One University Place Construction Update 5
02/14/16

TO: University Heights, Mayor, Council, and Staff
FROM: Josiah Bilskemper, P.E.
DATE: February 6, 2016
RE: City Engineer's Report

(4) One University Place – Public Improvements Project

ONE UNIVERSITY PLACE - PUBLIC IMPROVEMENTS

INITIAL CONTEMPLATED WATER MAIN ROUTE

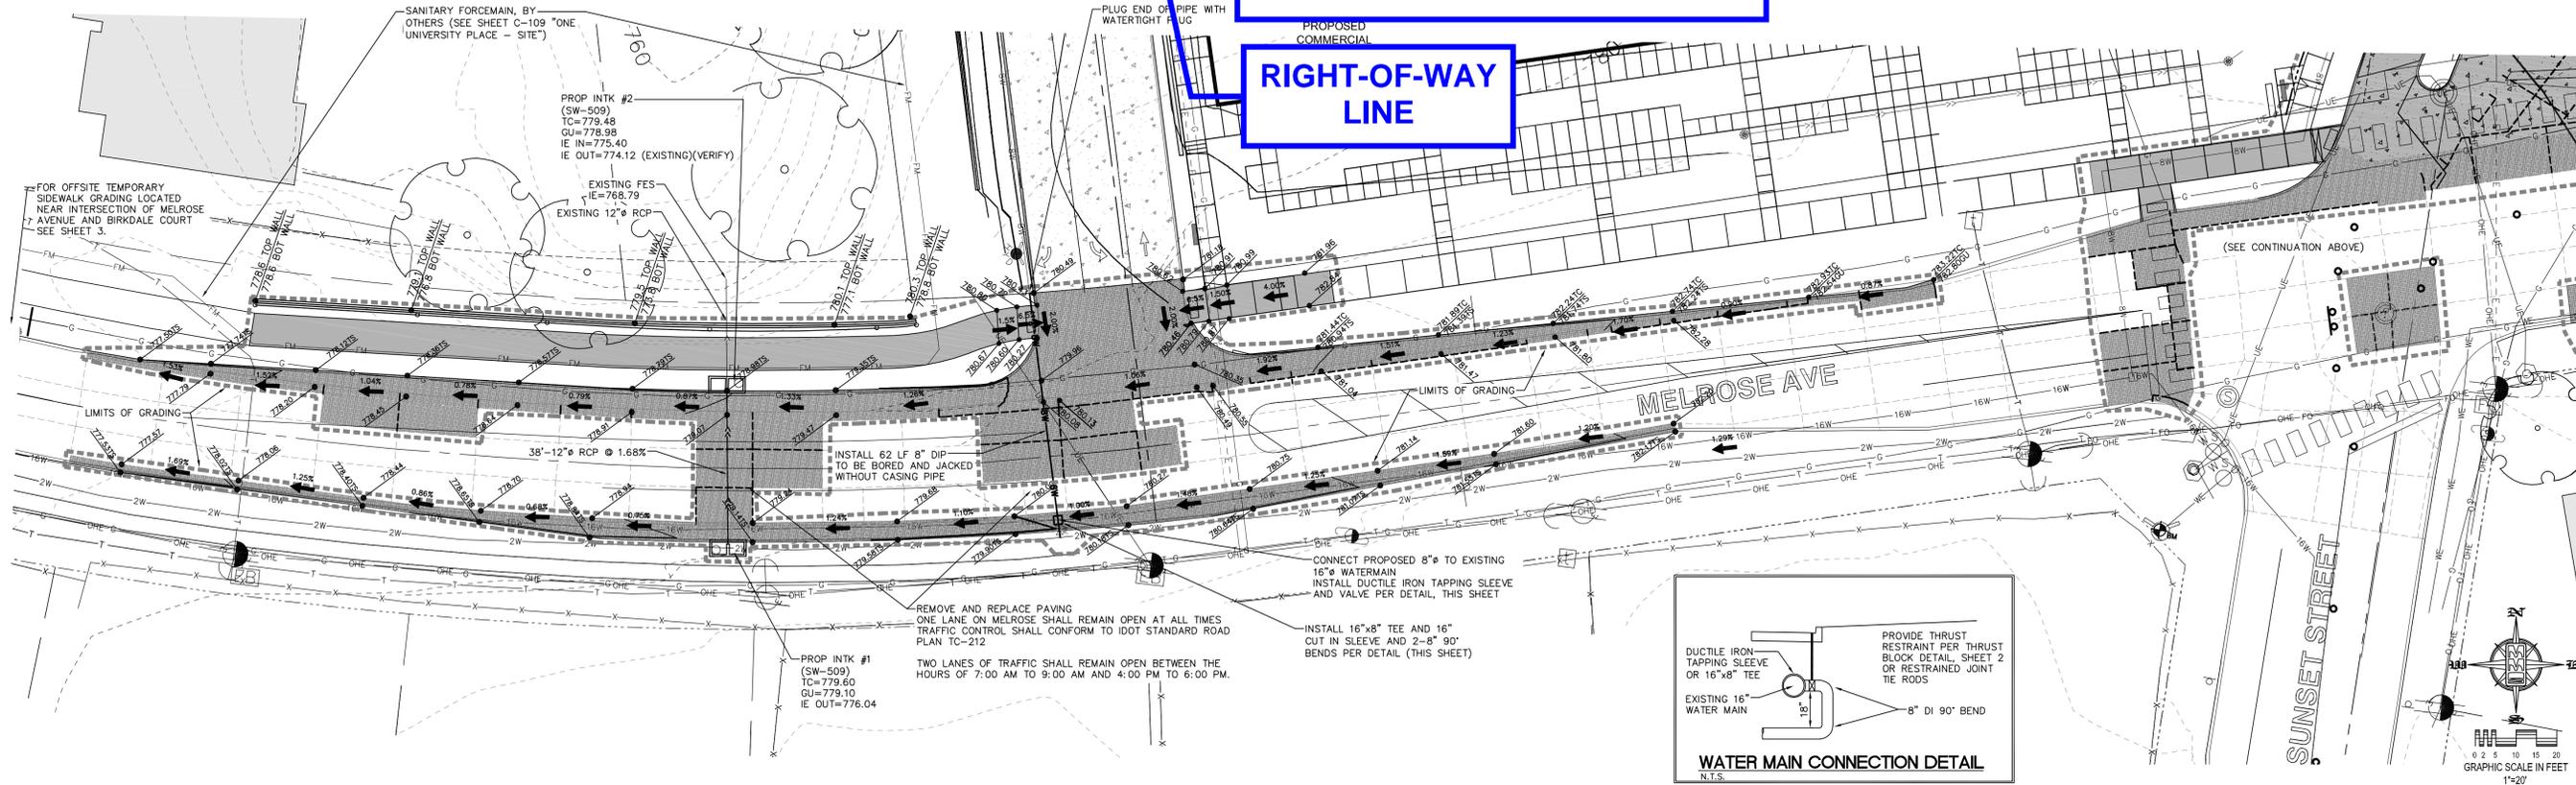
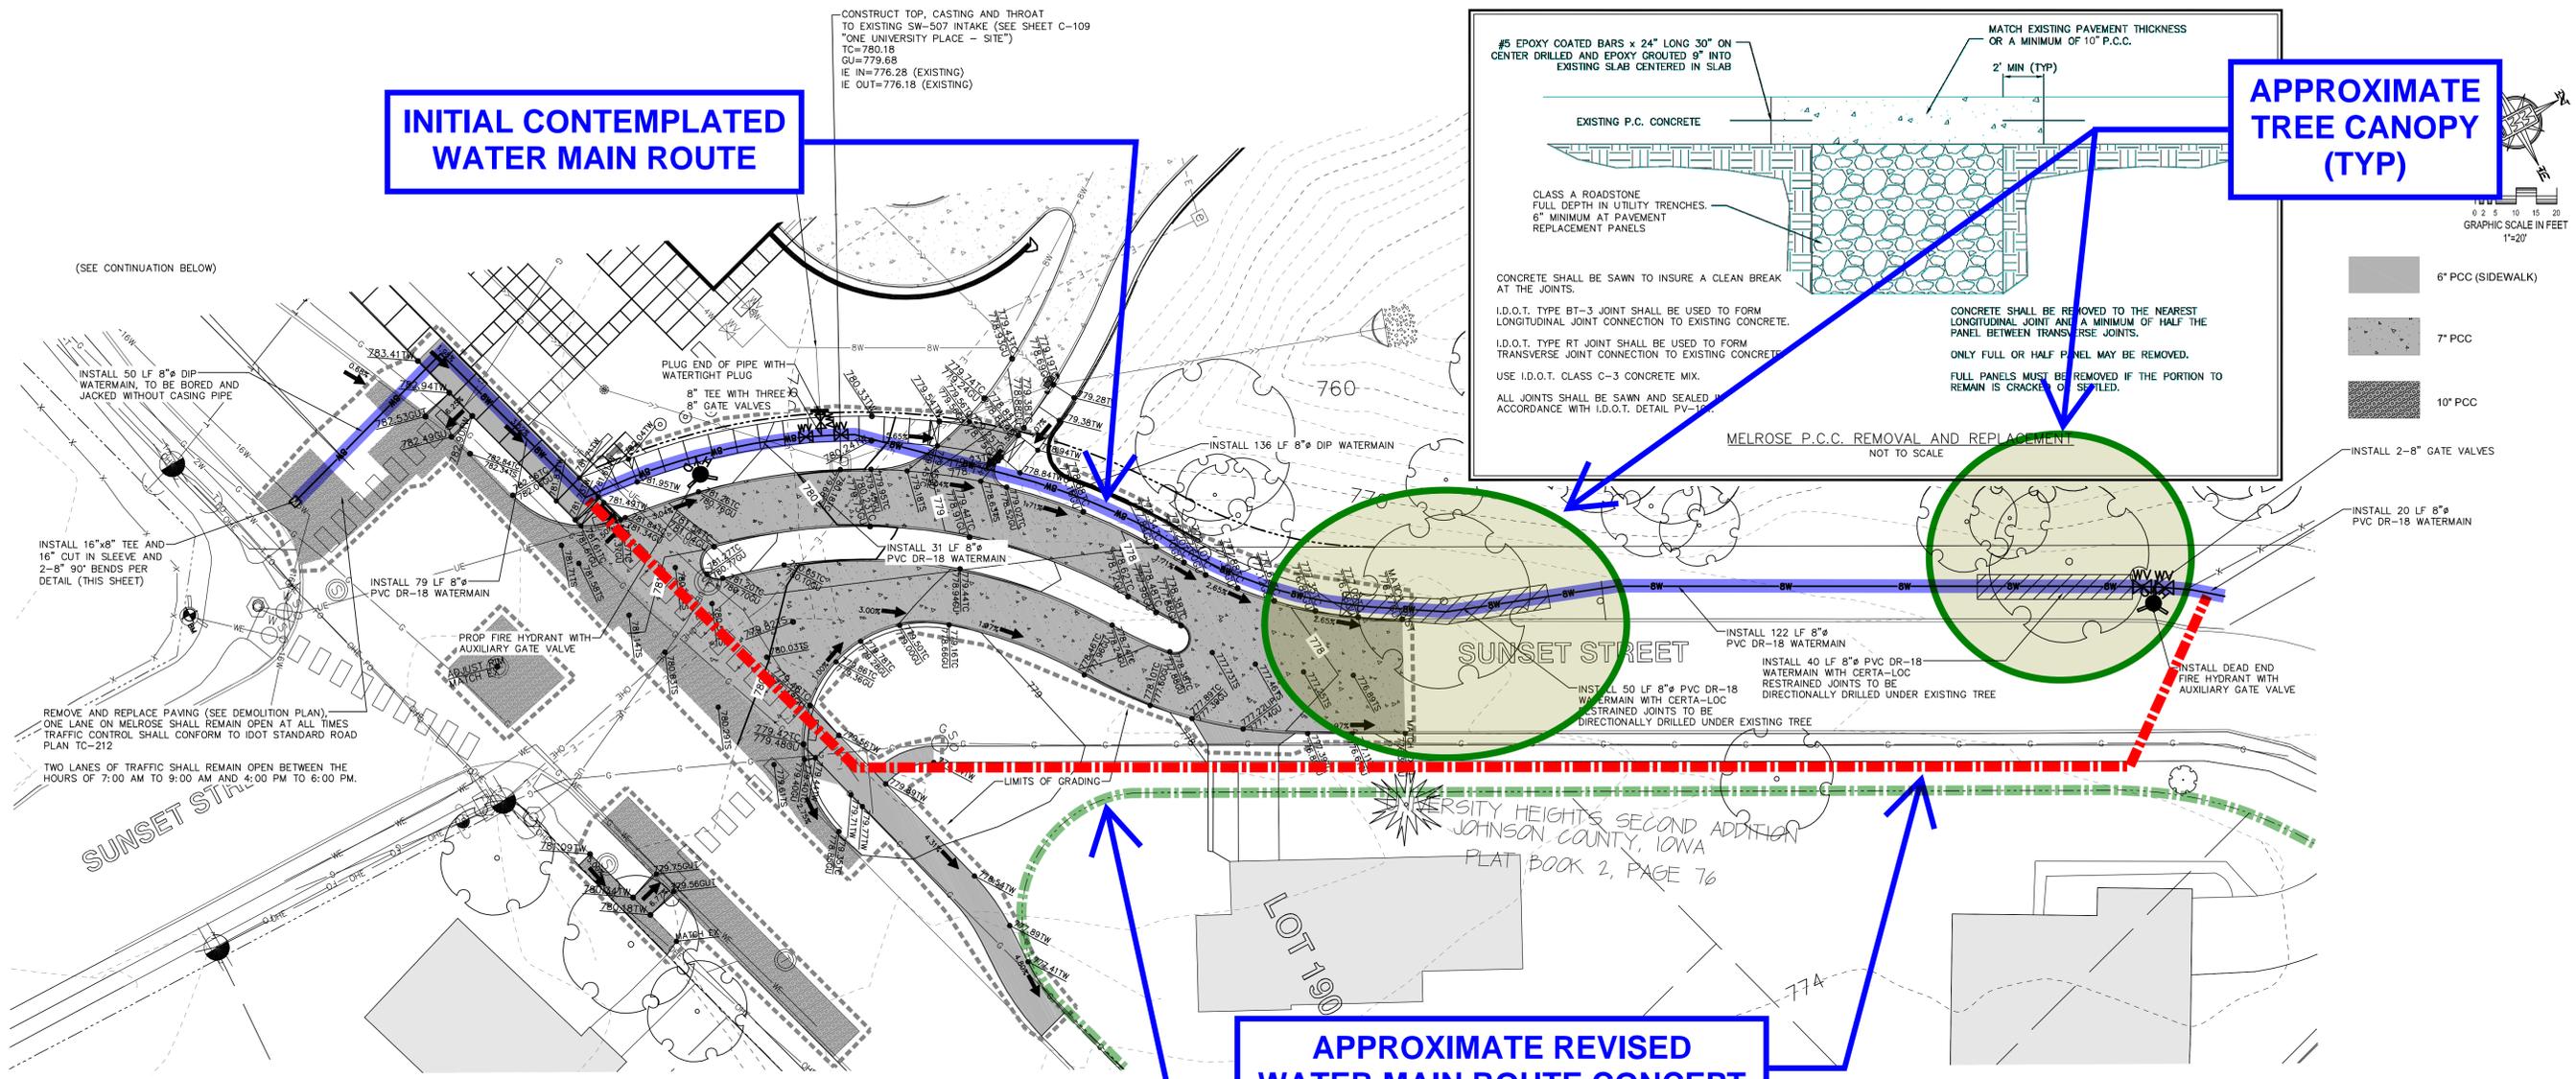
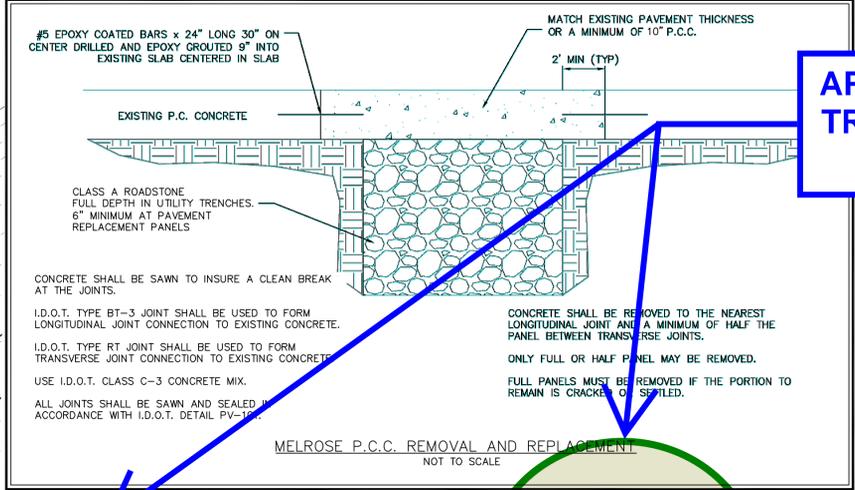
- iv. The last draft of the construction drawings showed installing this water main on the west side of the street (the ravine side of the street). The water main would be drilled underground at two locations to get under two large trees along the edge of the ravine. Since there is not much room between the street and the edge of the ravine, the alignment of the water main pipe would be very near the trunk of the trees. This creates an unknown risk that even though the pipe is drilled underground, there could be possible impact to any deep roots directly below the trunk.

- v. We are planning to proceed by moving this water main to the east side of the street, thereby eliminating this potential impact to the two existing large trees along the top of the ravine (both now from a construction standpoint, and possibly in the future from a maintenance or repair standpoint). The new water main would be located behind the sidewalk on the east side of the street, within the city's right-of-way, and extended to a point equal to the north corner of the developer's property. A hydrant will be located at the end of the main and placed near this property line.

- vii. Attached sketch shows initial routing considered on the west side, and the revised concept to install water main on the east side of Sunset Street.
